CASE/FILE: AR-15-25 (Community Development Dept.: Planning Division)

PROPOSAL	To construct a new restaurant at Nyberg Rivers, Cracker Barrel
-----------------	--

RE: Cracker Barrel at Nyberg Rivers Completeness Response for Architectural Review (AR-15-0025)

C2.0

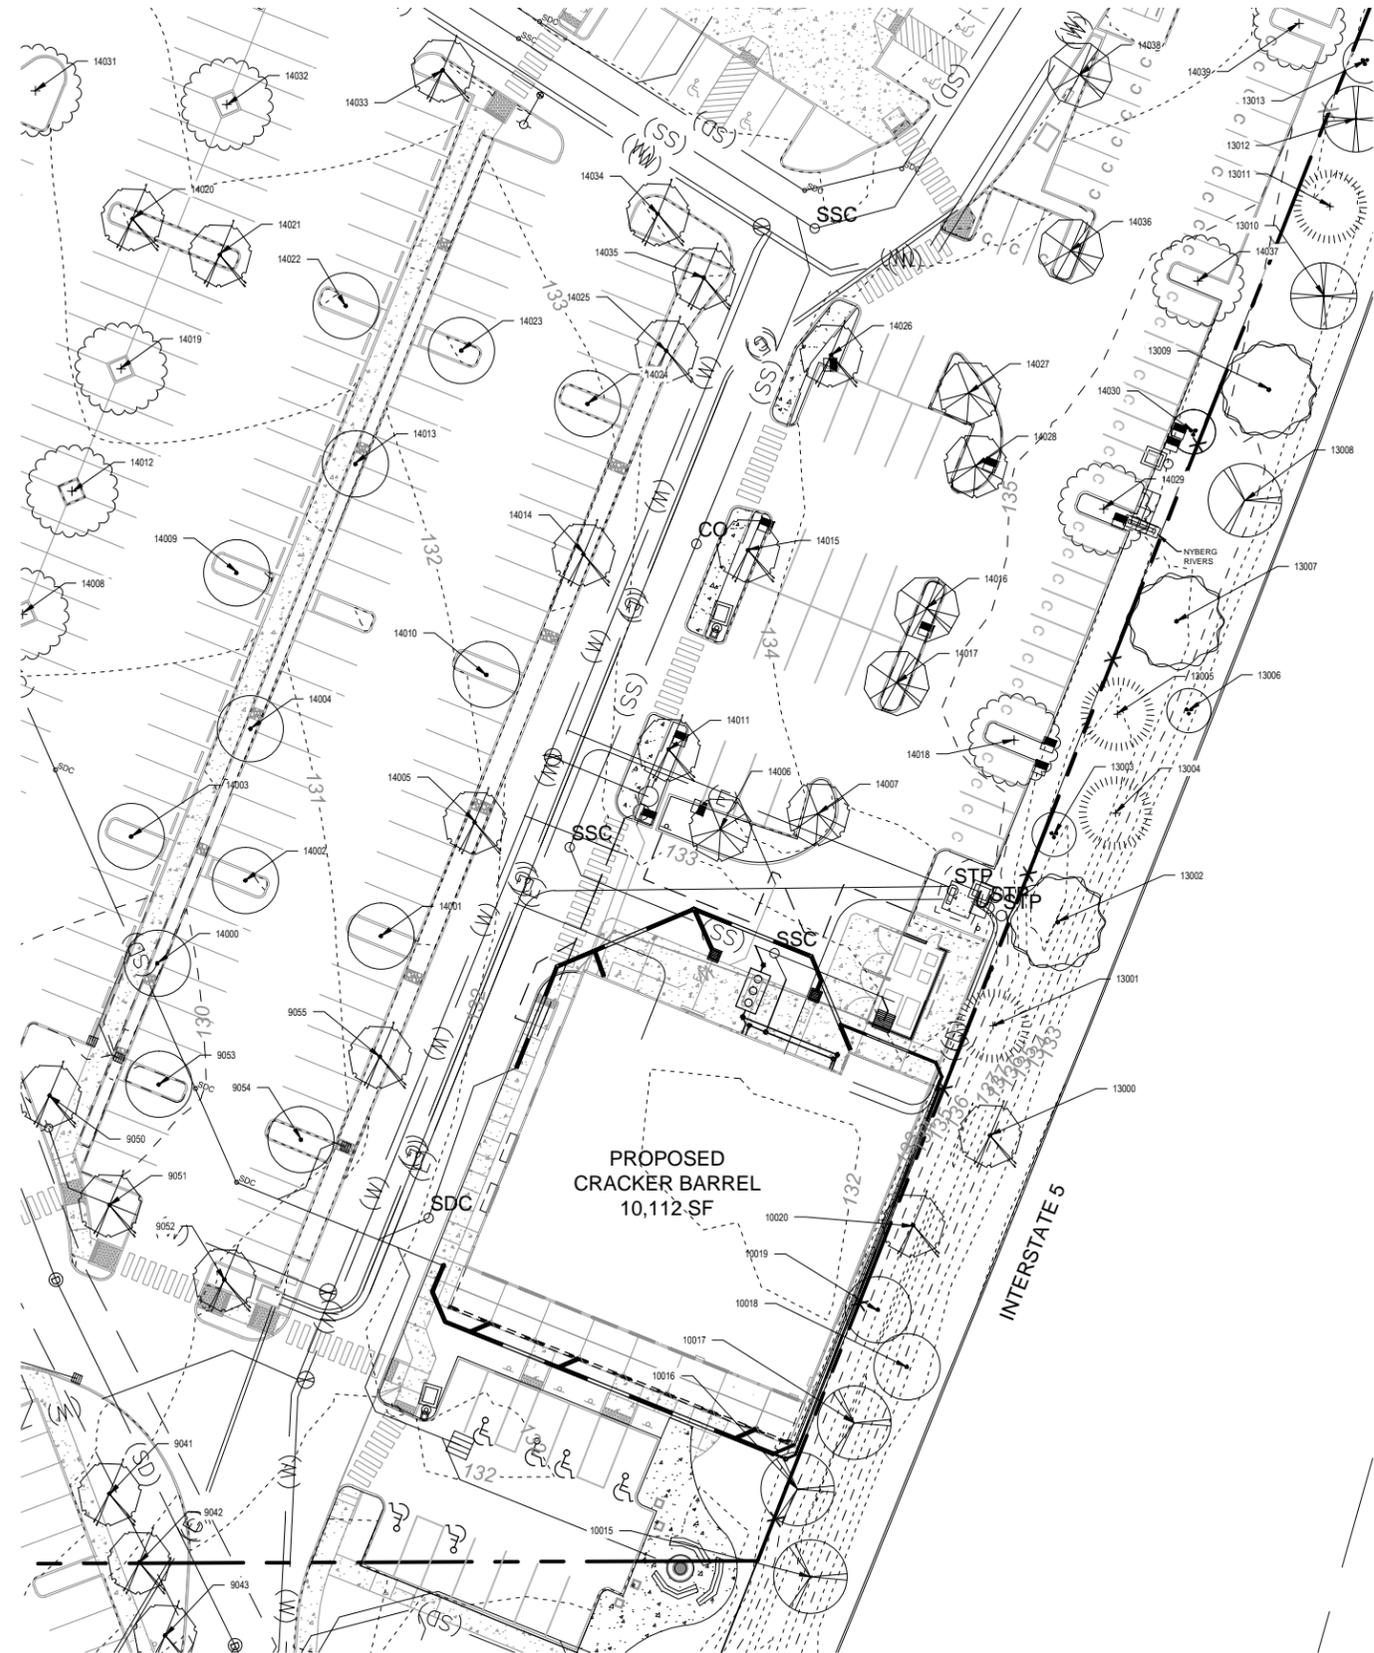
- 4. Please respond to Section 73.390 on the plans and in the narrative.**

Response: Tualatin Development Code Section 73.390 (Off-Street Loading Facilities) is addressed in the narrative on pages 40-43. The proposed loading berth is located on the north side of the building and is shown on Sheet C2.0 in Exhibit H.

© DOWL 2015
 SHEET
C3.0

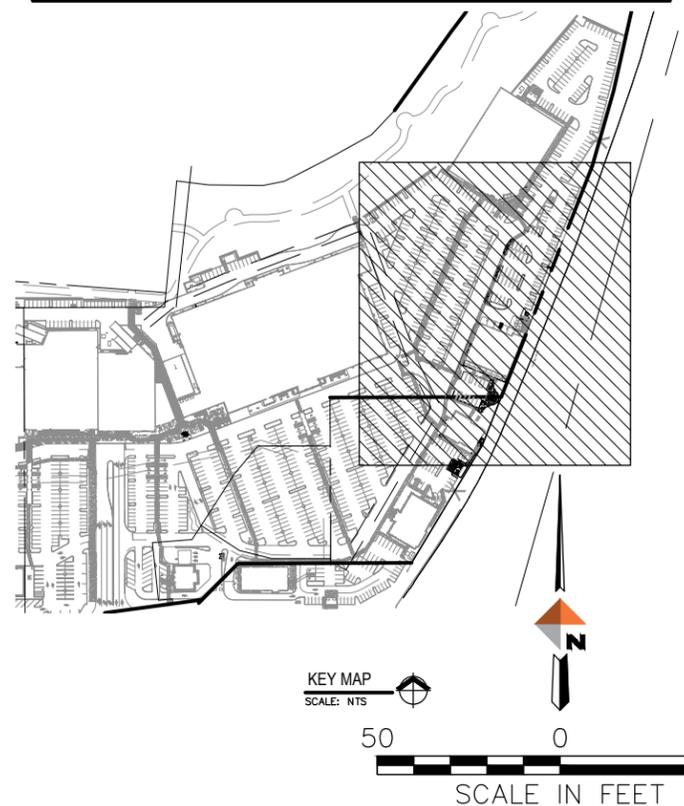
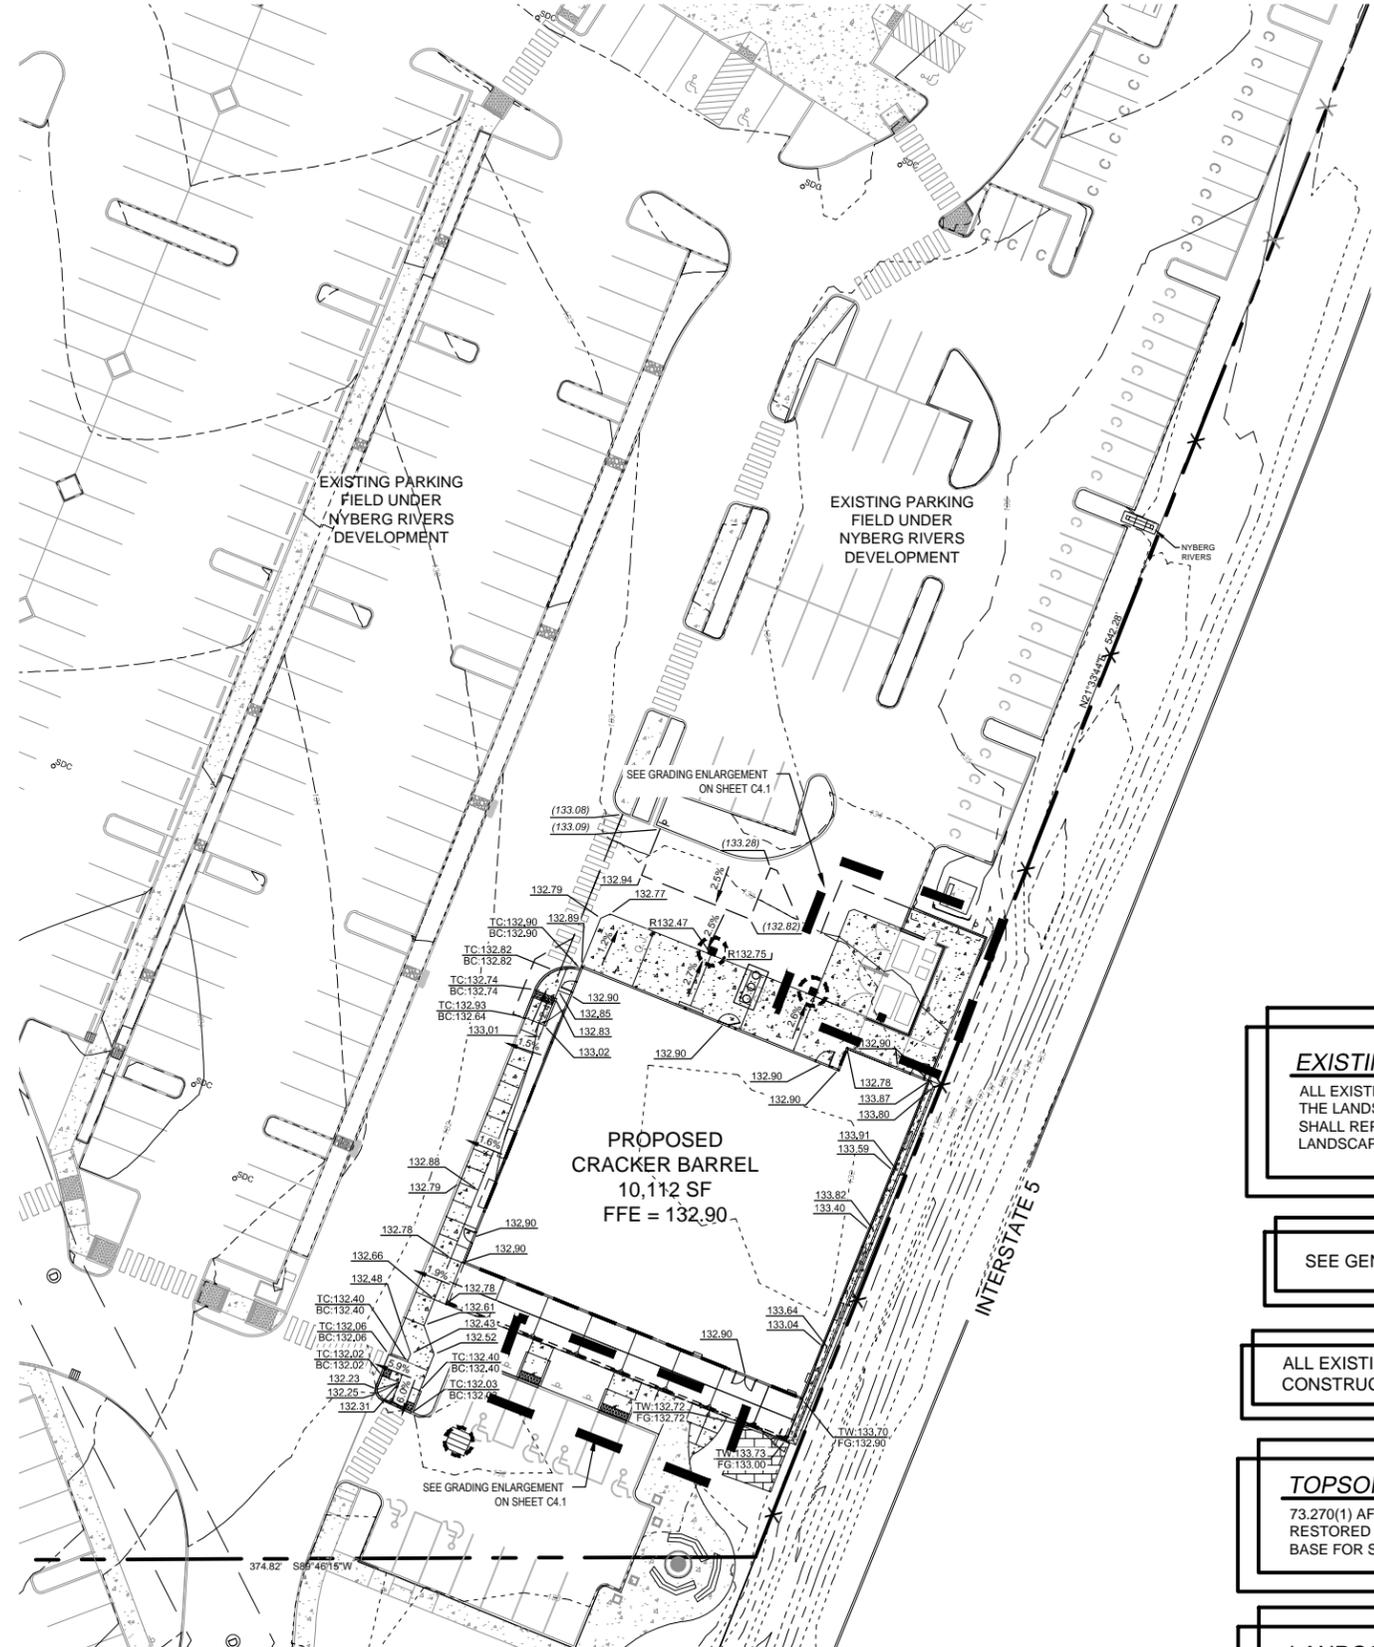
7. **The landscaping plan says that vegetation on the ODOT area will be protected, but that does not match with what is shown in the same area on the tree preservation plans, please explain and/or rectify. One Condition S tree is shown bolded, but the other Condition S trees are not, please explain. (Condition S is from AR-13-07 from the Nyberg Rivers Shopping Center approval)**

Response: Sheets C3.0, C3.1 and L1.0 in Exhibit H identify landscaping in the ODOT right-of-way for reference only. Plants in this area are not part of this project and are separated from the Cracker Barrel site by an existing 6’ chain link fence. The fence and landscaping within the right-of-way will be protected by the construction contractor and will remain undisturbed through the duration of building construction.

Three replacement trees that will replace Condition ‘S’ trees are identified on L1.0 of Exhibit H. All replacement trees are the same line weight to address this previous concern.

©DOWL 2015
 SHEET
L1.0

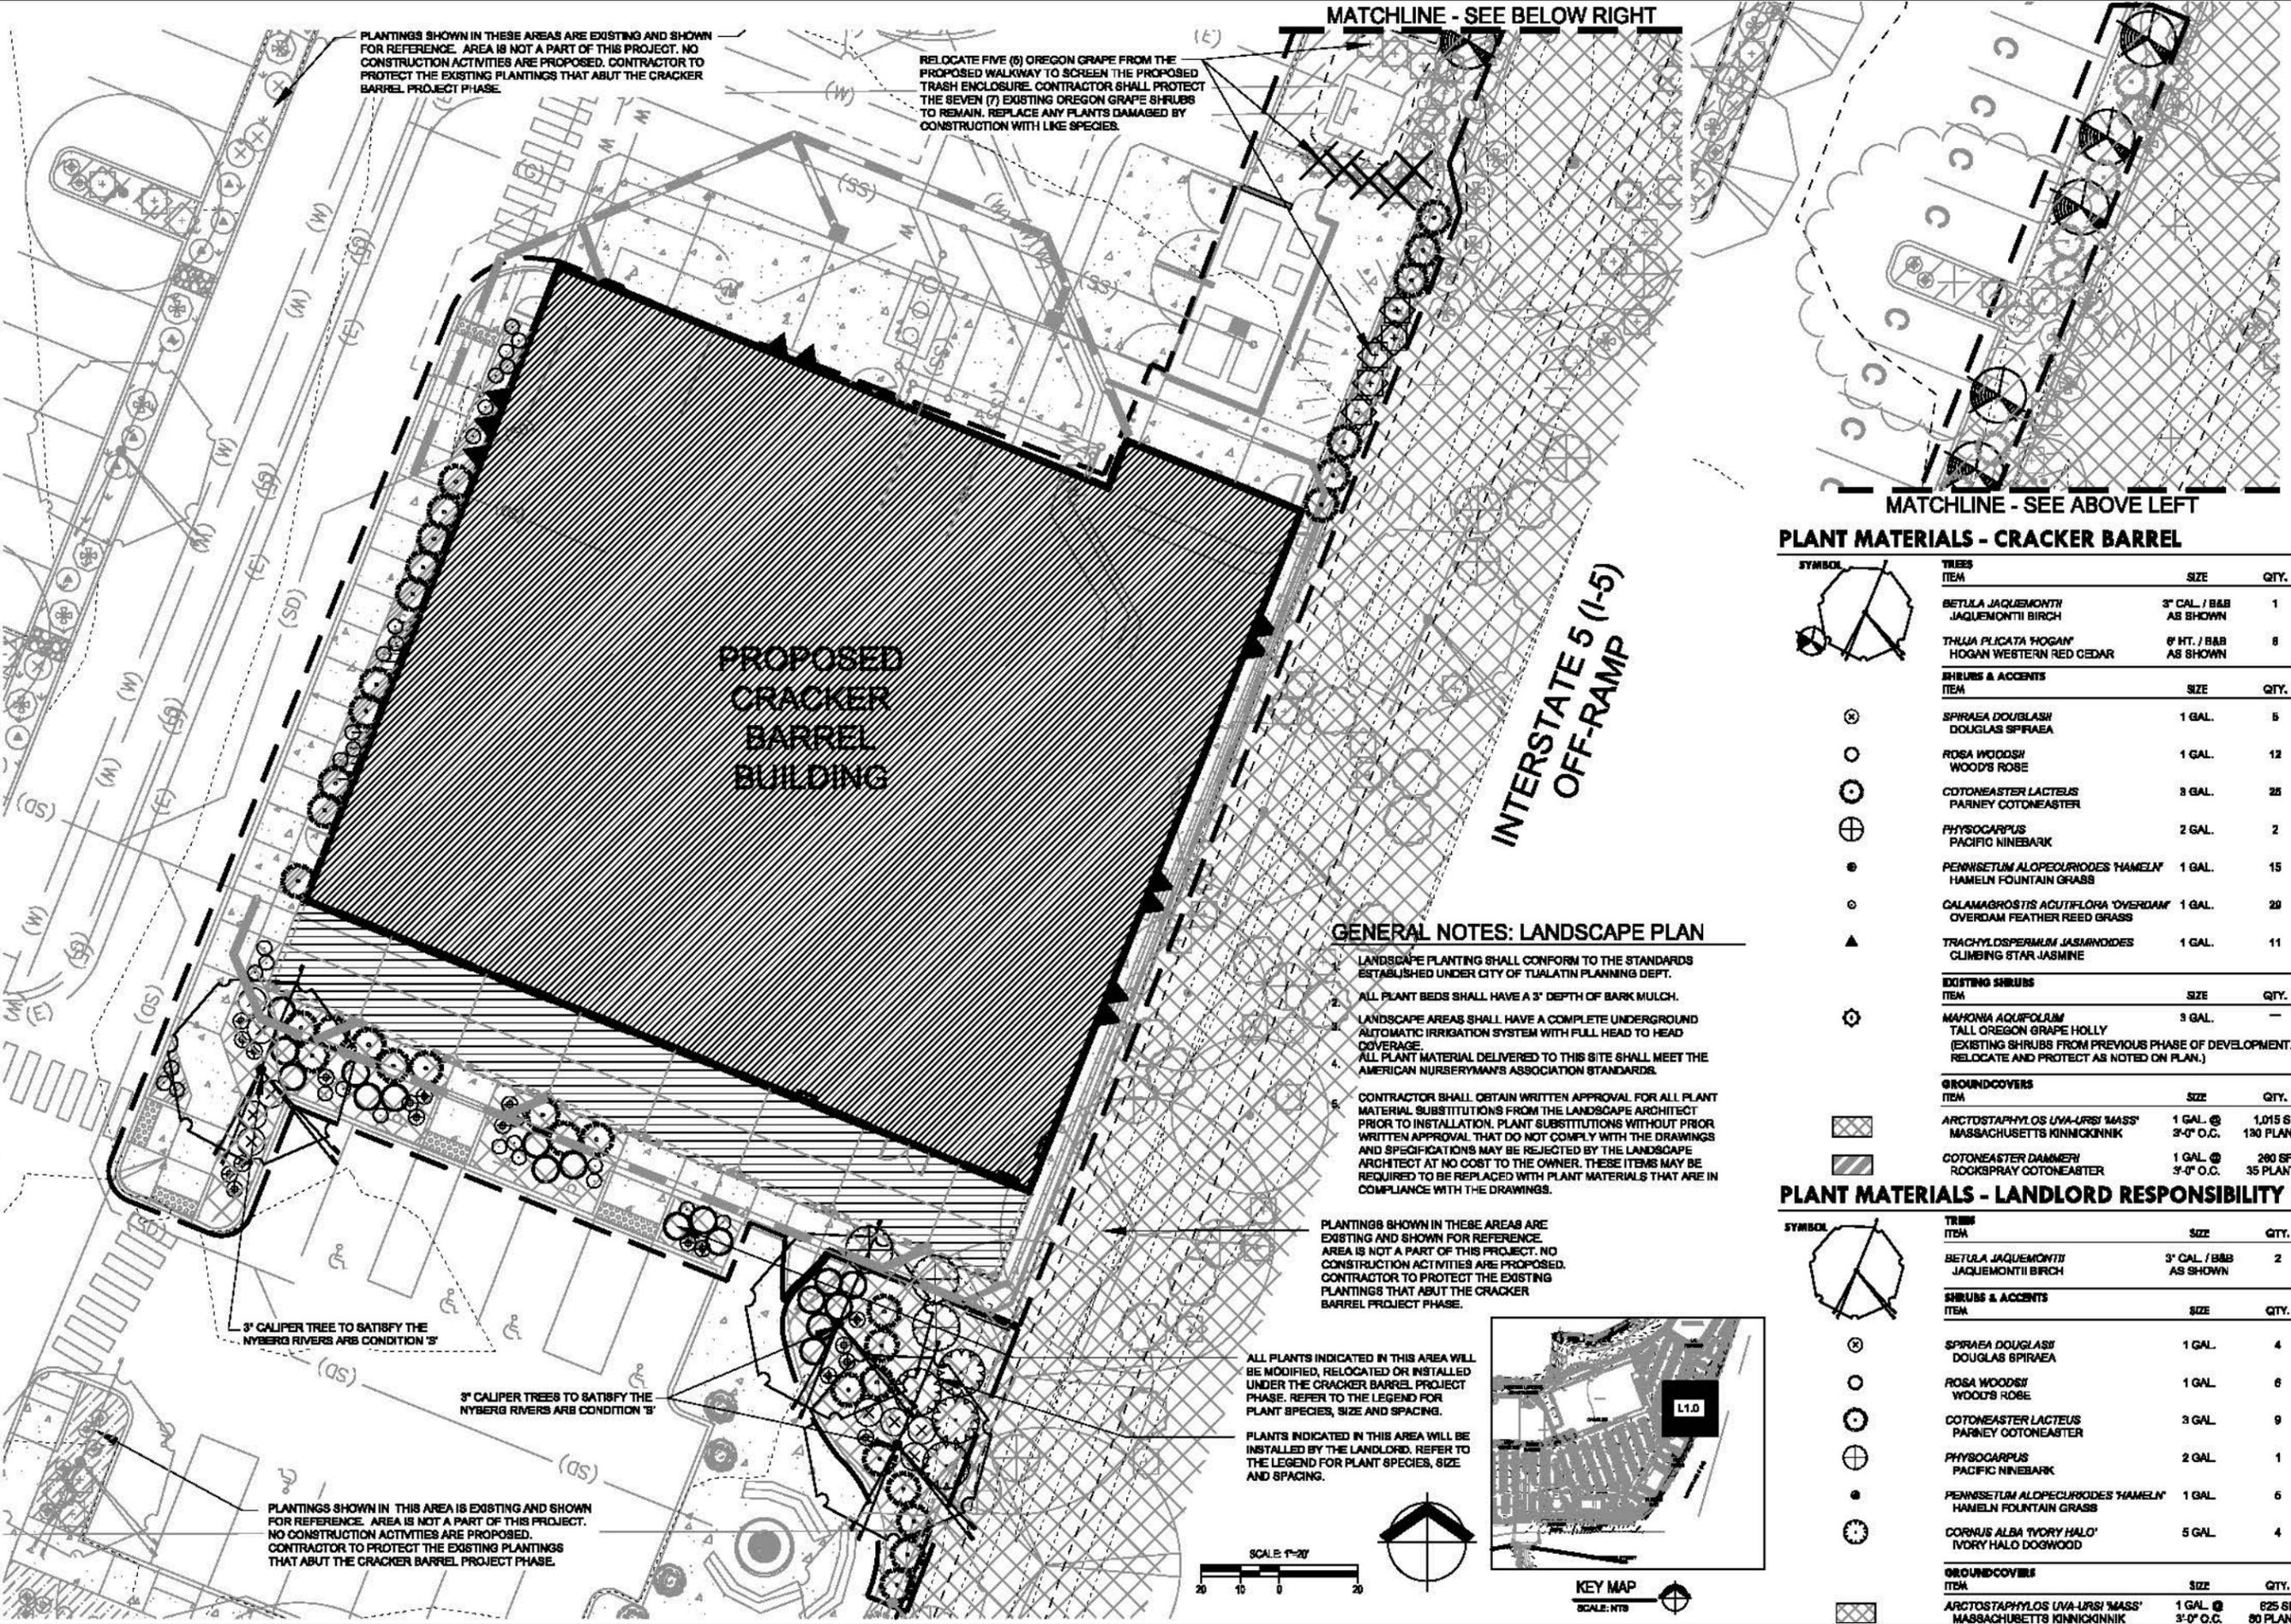
6. **The landscaping plan indicates some vegetation will be installed, relocated, or replaced, but are shown in a “faded out gray” line type that is reserved for existing plans on the rest of the plans. Please rectify.**

Response: As shown on Sheet L1.0 in Exhibit H, the landscape plan uses a dark line type to indicate vegetation to be installed, relocated, or replaced. Existing plantings are shown in a gray line for contrast from vegetation to be installed, relocated, or replaced.
